10/728,734 filed 12/05/2003

Chien et al.

Reply to Office action of 03/22/2007

Amendments to the Drawings:

Figure 4A

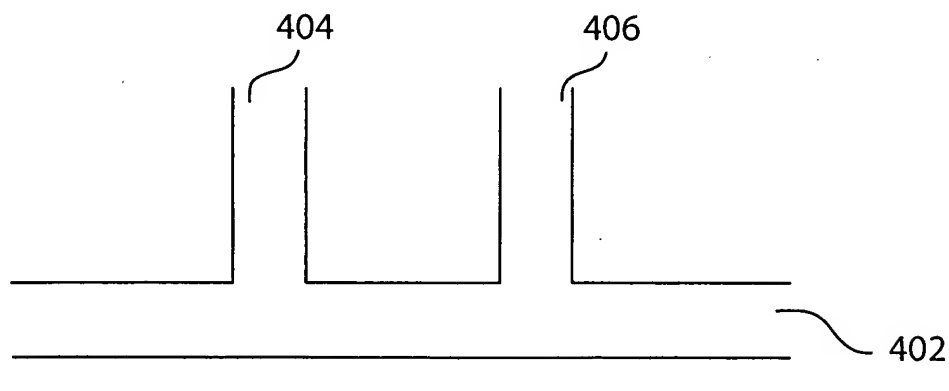
Added
reference
numbers
402, 404, 406

Figure 4B

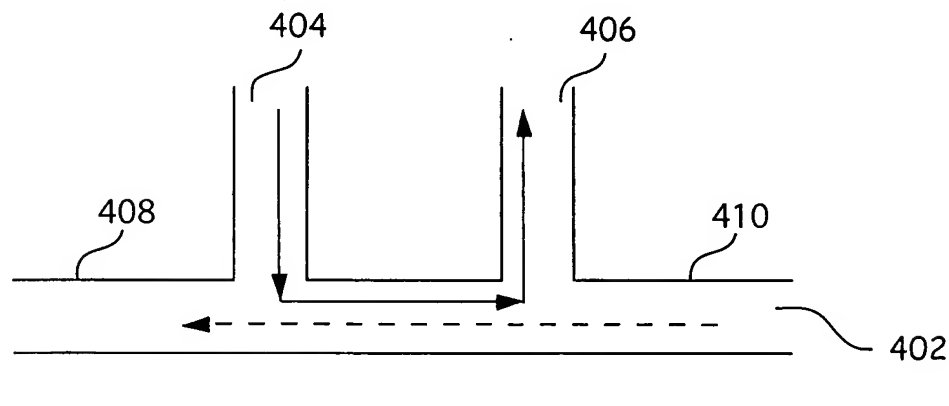
Added
reference
numbers
408, 410
